LTB01108NAS4

TECHNICAL BULLETIN

415-01: Information and Entertainment Systems

InControl® Touch Pro™ Features May Not Function As Expected; Phase 4 Updates

E229092

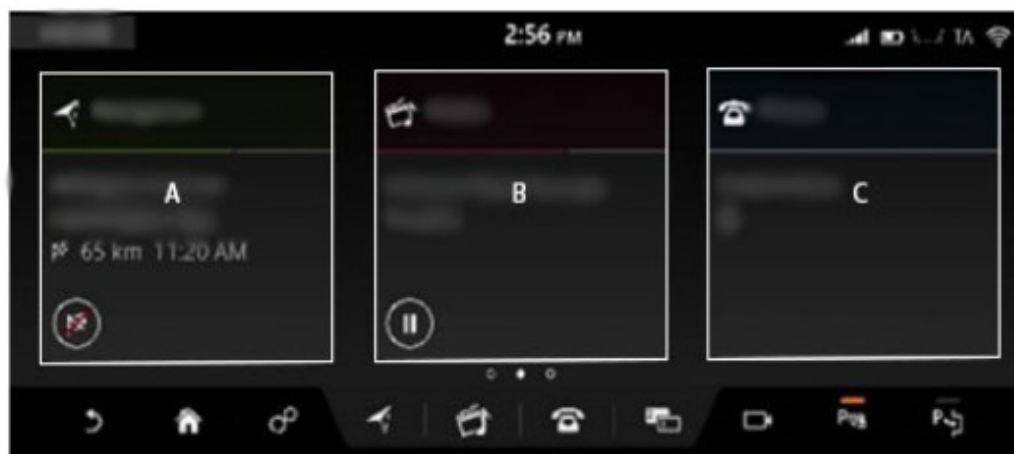
A major part of this update is to the look & feel of the single-screen InControl Touch Pro system, which will change to match that of the InControl Touch Pro Duo system. Once this software update is completed, it CANNOT be reversed.

Vehicles with Single-Screen System - current 4-tile look & feel home screen:

- A - Media
- B - Climate Control
- C - Phone
- D - Navigation

Vehicles with Single-Screen System - updated 3-tile look & feel home screen:

- A - Navigation
- B - Media
- C - Climate Control
